Objet : PRODUCT MATURITY INFORMATION

**OBSOLESCENCE OF PARTS FOR CPU CARDS ON HF9/HF QUADRO CONTROLLERS
(nr. 2506.6201 / 2506.7201 / 2506.8201)**

**OBSOLESCENCE of parts for the CPU cards on HF9/HF QUADRO controllers
(nr. 2506.6201 / 2506.7201 / 2506.8201)**

View of memory card and CPU

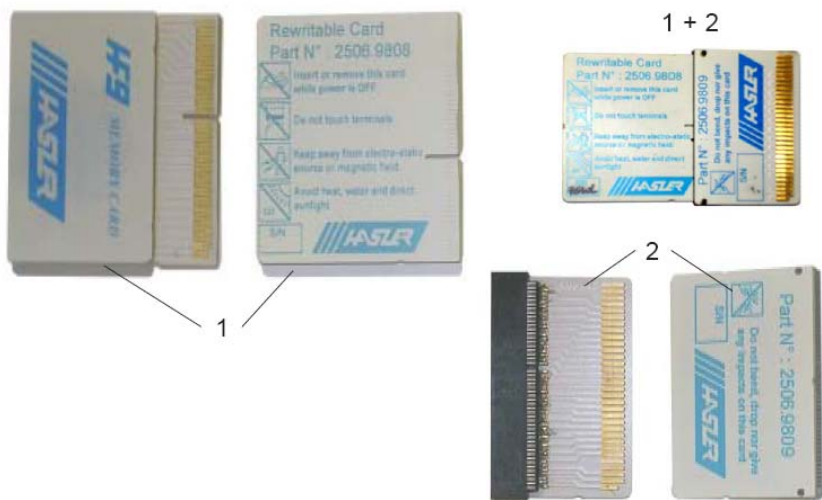
The HF9 CPU card connector (number 2506.6201, 2506.7201, 2506.8201) that takes the Beecard has transitioned to the “mature” product phase, effective immediately by our suppliers.

This connector is replaced by a SAMTEC connector on HF9 CPU cards (number 2506.6202, 2506.7202, 2506.8202) sold currently.

- a new memory card (Beecard2) number 2506.9808 that carries the memory, compatible with the new HF9 CPU card connector number 2506.6202, 2506.7202, 2506.8202.
- a compatibility adapter for the new Beecard2 with the old HF9 CPU card connector number 2506.6201, 2506.7201, 2506.8201.

- (1) memory card Beecard2 nr. 2506.9808
- (2) adapter nr. 2506.9809 for memory card Beecard2 on an old CPU card

It is not possible to use memory cards numbers 2506.9805 and 2506.9807 on new CPU cards.

If an old CPU card must be replaced by a new one, the recording of parameters on a new memory card **must be carried out first** as explained in our manual ref. BEECARD.943.001-E.a, enabling the transfer of parameters between the old and the new CPU card.
